LEGG ARCHITECTURE, LLC

May 03, 2023

Lion & Rose British Tavern and Pub - 23110 W I-10, San Antonio, TX 78257

ADDENDUM 1

JOB #: C-2213
DATE: 1/28/2023
DESIGN: N.M.R.
DRAWN: N.M.R.
CHECKED:
SHEET: C-4.0

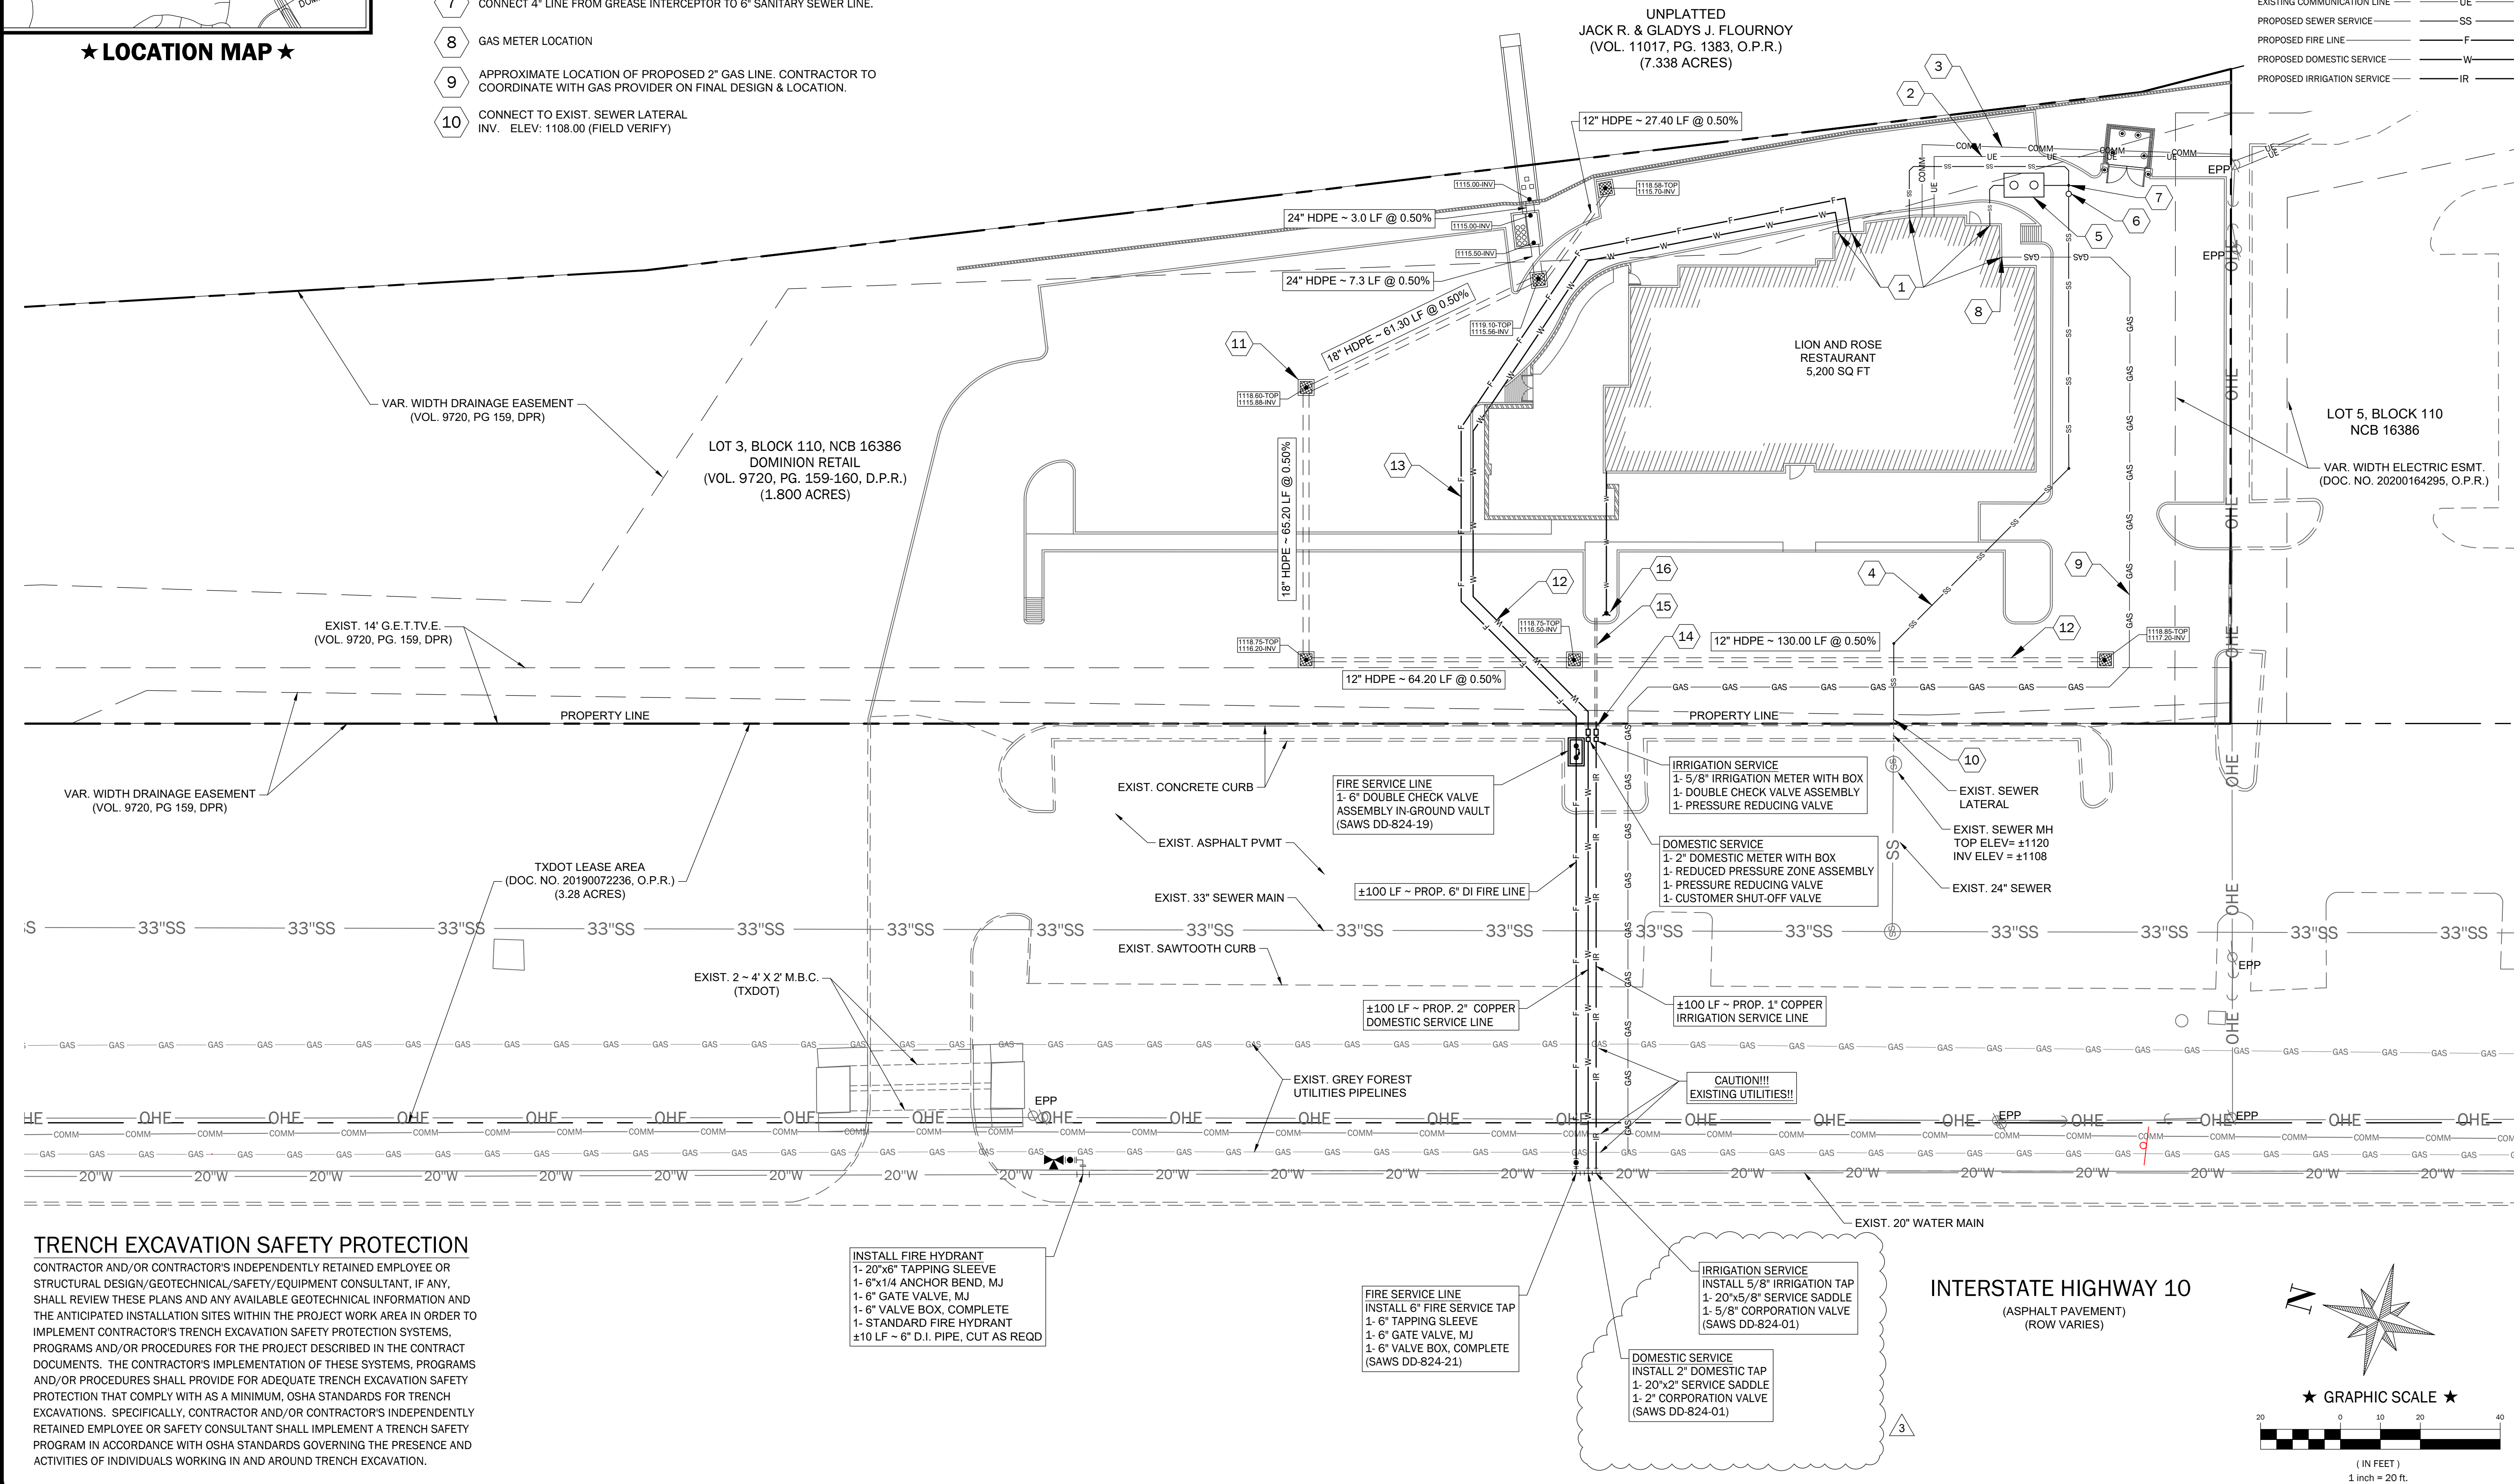
- 1.1 Added FDC
- 1.2 Extended concrete drain outfall in creek
- 1.3 Added Compact parking spaces and associated stripping.
- 1.4 Added a bike rack
- 1.5 Widened the one-way drive lane
- 1.6 1" Irrigation meter changed to 5/8" meter
- 1.7 Allow for '**RESERVED**' parking sign at main restaurant entrance (not indicated on civil).

SHEET NO.
A2.1

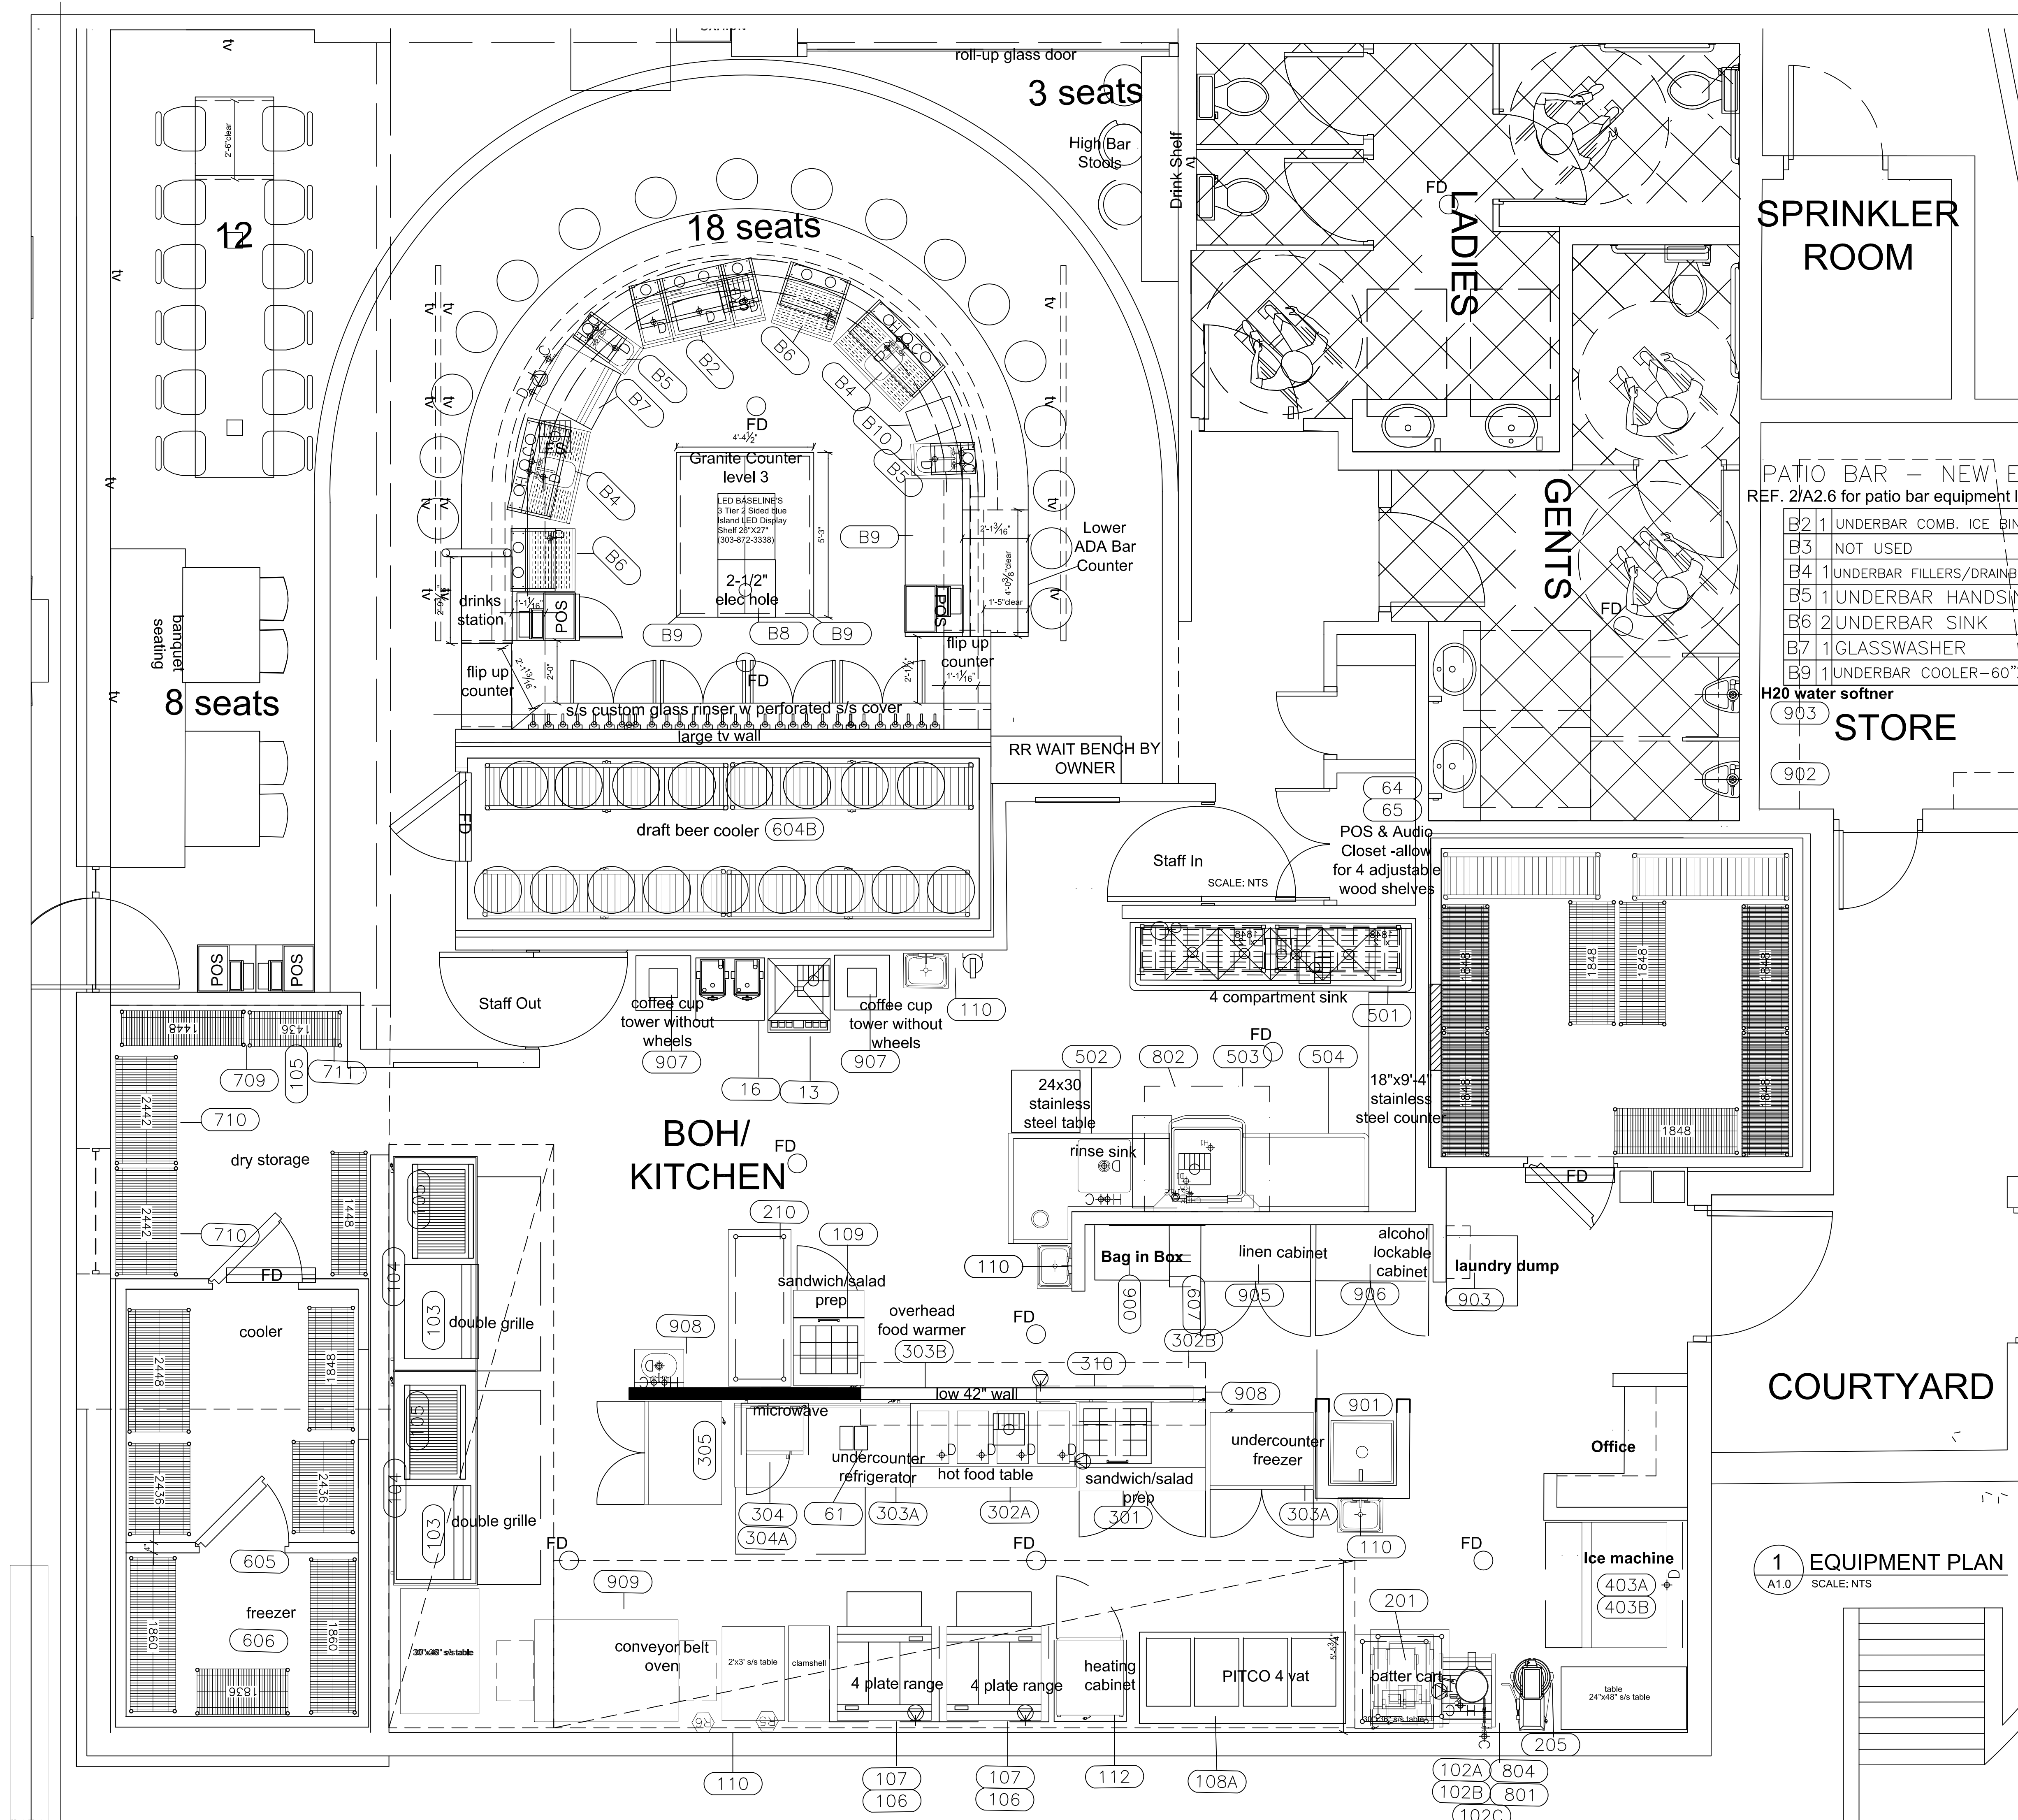
- 3.2 Sheet A2.1 Kitchen Equipment – Items 801; 802 & 803 are by main contractor.
- 3.3 Sheet A6.6 Copper sheet finish specification – 16mil 26 ga for main bar wall finish and 10mil 30 ga copper gutter details for clay roof tiles. Main Bar – 36" minimum width roll horizontal with minimum 84" horizontal copper seam and vertical copper trim at corner returns
(info@basiccopper.com phone at 252-491-2812)
